Delegated Report		Analysis sheet		Expiry Date:	28/09/2020
		N/A		Consultation Expiry Date:	18/10/2020
Officer			Application Number(s)		
Tony Young			2020/3499/P		
Application Address			Drawing Numbers		
6 Constantine Road London NW3 2NG			Refer to draft decision notice		
PO 3/4	Area Team Signature	C&UD	Authorised Officer Signature		
Proposal(s)					
Alterations at rear ground floor level, involving the insertion of new aluminium framed double-glazed window within existing chimney breast (following removal of small timber framed window); and the replacement of uPVC / aluminium framed doors with aluminium framed double-glazed, bi-folding doors and fixed glazed panels within enlarged flank wall opening.					
Recommendation(s):		Refuse planning permission			
Application Type:		Householder application

1. Proposal

Image 1 - showing the rear elevation with proposed window inserted into chimney breast

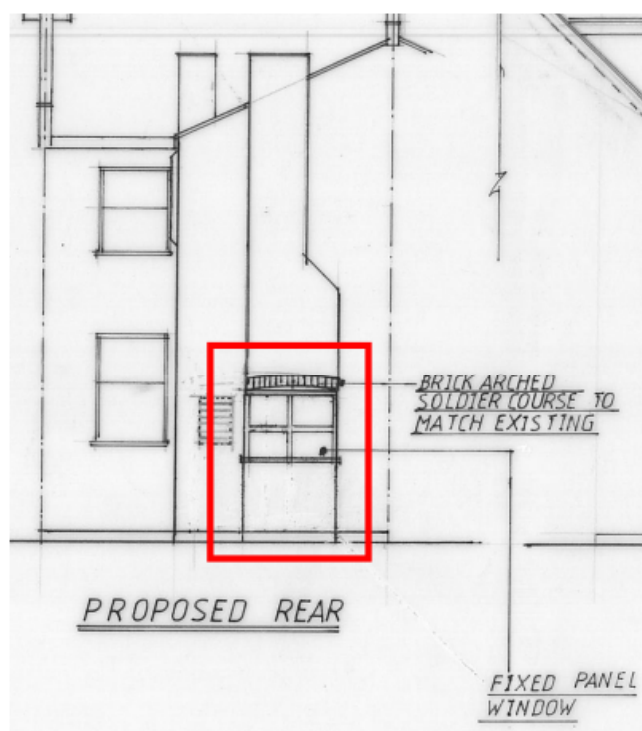
4.7 The proposed window would be a fixed panel window with glazing bars. The appearance would be at odds with the existing fenestration at the property which are mainly timber sash windows characterised by a vertical sliding method of opening and absence of glazing bars. The proposed window would also have a strong horizontal emphasis and proportions that do not match or relate to existing fenestration. This would be contrary to Camden Planning Guidance CPG (Home improvements – Section 3.1) which advises that *“New windows and doors should generally be designed and composed of materials and finishes sympathetic to the original window and/or doors to the building.”*

4.9 Furthermore, while the absence of fenestration in this elevation does not preclude the insertion of a suitably designed and positioned window, in this instance, the insertion of the proposed window within an opening cut into a chimney breast would be an unusual and inappropriate place for a window to be located. More importantly, it would interrupt and cut through an architectural feature of the building. As such, the proposal would result in a very odd and incongruous appearance in

this elevation, and in so doing, damage the architectural integrity of the building and harm the character and appearance as a whole.

- 4.10 It is noted that the proposed side elevation drawing (ref. KS/2020/03 rev C) shows the proposed removal of the lower part of the chimney breast at its base (see Image 2 below). This alteration in form is inconsistent with the proposed rear elevation drawing (also ref. KS/2020/03 rev C) and window details drawing (ref. KS/2020/04 rev B) which appear to show the chimney breast as being unaltered apart from the insertion of the proposed window within a new opening cut into it (see Image 1 below). As such, notwithstanding the design concerns associated with this alteration, this also raises structural concerns which further emphasise the unsuitability of the proposals. The applicant was offered the opportunity to provide an amended side elevation drawing to be included as part of final revisions for the application proposals; however, no amendments were submitted to the Council.
